# Access Compliance Report

## Public Rights-of-Way

### (Curb Ramps)

Intersection ID: 14731	Main Street: NORLAND_RD	Cross Street: WOODLAND_DR	Location: W
ADA ID: 4626567AD72C	Ramp Type: Para	Initial Pass/Fail: Fail	Overall Compliance: No
		Severity Score: 1.25

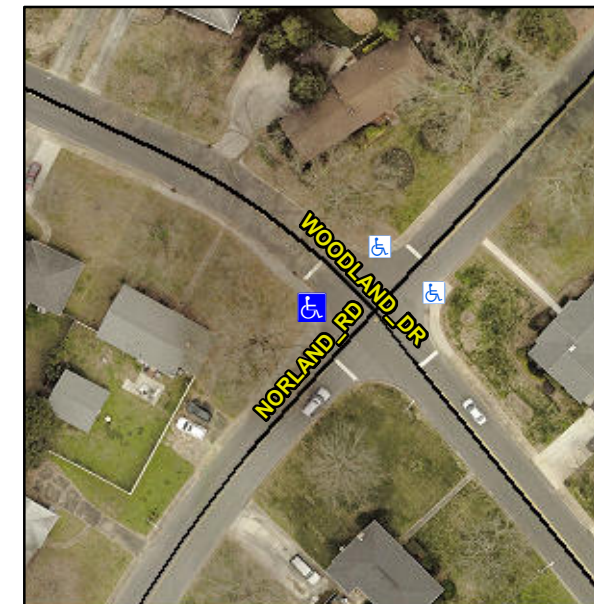
**LT RP < 5%**

**R304.5.3**

Compliance	Description	Data	Compliance	Description	Data
N/A	Ramp Length LT (in)	72.0	N/A	Ramp Length RT (in)	45.0
Yes	Ramp Width LT (in)	70.5	Yes	Ramp Width RT (in)	70.0
Yes	Ramp Slope LT (%)	1.6	Yes	Ramp Slope RT (%)	5.1
Yes	Ramp XSlope LT (%)	1.1	No	Ramp XSlope RT (%)	3.1
N/A	Landing Length (in)	N/A	N/A	DWS Provided?	N/A
N/A	Landing Width (in)	N/A	N/A	DWS Contrast?	N/A
N/A	Landing Slope (%)	N/A	N/A	DWS Length (in)	N/A
N/A	Landing X Slope (%)	N/A	N/A	DWS Full Width?	N/A
N/A	Landing Curb? (Y/N)	N/A	N/A	DWS Offset (in)	N/A
N/A	Shared Landing?	N/A			
N/A	Gutter Ponding?	N/A	N/A	Gutter Slope (%)	N/A
N/A	Gutter Lip Ht (in)	N/A	N/A	Gutter X Slope (%)	N/A
N/A	Painted X Walk1?	No	N/A	Painted X Walk2?	N/A
	X Walk 1 Direction	To NE		X Walk 2 Direction	N/A
N/A	X Walk 1 Width (in)	N/A	N/A	X Walk 2 Width (in)	N/A
	X Walk 1 Slope (%)	3.9		X Walk 2 Slope (%)	N/A
	X Walk 1 X Slope (%)	4.5		X Walk 2 X Slope (%)	N/A
N/A	Ramp inside XWalk1?	N/A	N/A	Ramp inside XWalk2?	N/A

**Remove & Replace Entire Ramp.**
